Calvert Cliffs Nuclear Power Plant, Units 1 and 2
Renewed Facility Operating License Nos. DPR-53 and DPR-69
NRC Docket Nos. 50-317 and 50-318

Subject: License Amendment Request
Proposed Changes to Technical Specification (TS) 3.8.1 Emergency Diesel
Generator Surveillance Requirements for Frequency and Voltage Tolerances
(using WCAP-17308 methodology)

**ATTACHMENT 1
License Amendment Request**

Markup of Proposed Technical Specifications Page

3.8.1-13

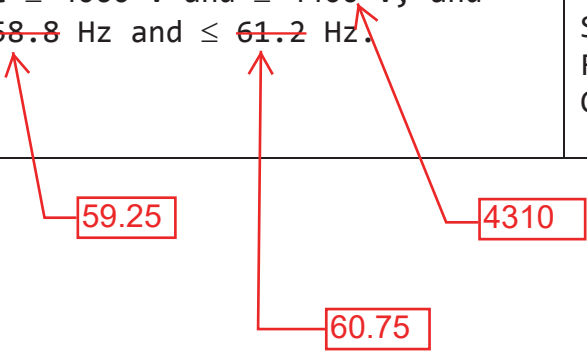
SURVEILLANCE	FREQUENCY
<p>SR 3.8.1.3 -----NOTES -----</p> <p>1. Performance of SR 3.8.1.9 satisfies this Surveillance Requirement.</p> <p>2. All DG starts may be preceded by an engine prelube period and followed by a warmup period prior to loading.</p> <p>3. A modified DG start involving idling and gradual acceleration to synchronous speed may be used for this Surveillance Requirement as recommended by the manufacturer. When modified start procedures are not used, the voltage and frequency tolerances of SR 3.8.1.9 must be met.</p> <p>-----</p> <p>Verify each DG starts and achieves steady state voltage ≥ 4060 V and ≤ 4400 V, and frequency ≥ 58.8 Hz and ≤ 61.2 Hz.</p>	<p>In accordance with the Surveillance Frequency Control Program</p>

A frequency tolerance of $60 \text{ Hz} \pm 0.75 \text{ Hz}$ and a voltage tolerance of 4060 V to 4310 V have been selected to ensure minimum operability issues with safety-related pumps, fans, and MOVs. The proposed changes are identified in red italics in below table:
